**Product Change Notification
Software Release Notice**

MultiConnect[®] rCell 100 Series Cellular Routers

**mPower[™] Edge Intelligence
Now Available - mPower 5.3.X Firmware**

Product Change Notification (PCN) Number
PCN 12142020-001 (mPower - MTR)

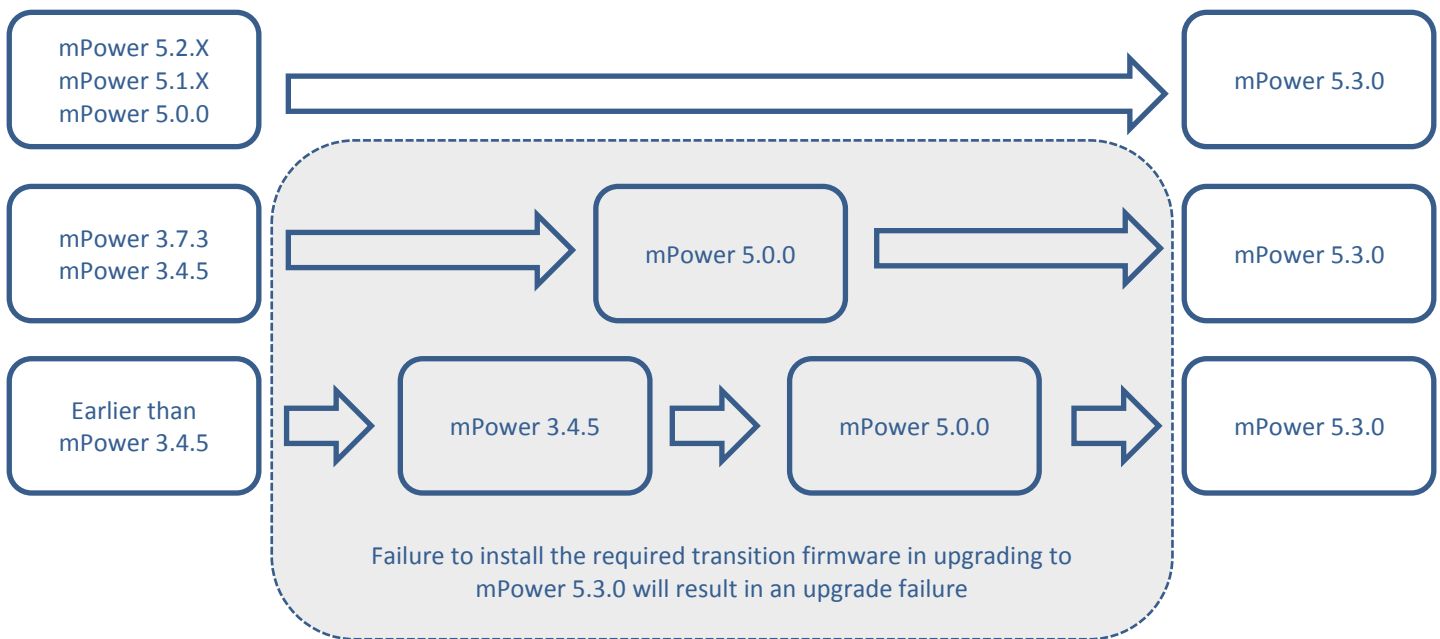
API Command Changes (MTR 5.3.X):

The MultiConnect rCell 100 Series Router uses the RESTful JSON API for managing configurations, polling statistics, and issuing commands. mPower MTR 5.3.X versions include a number of API changes.
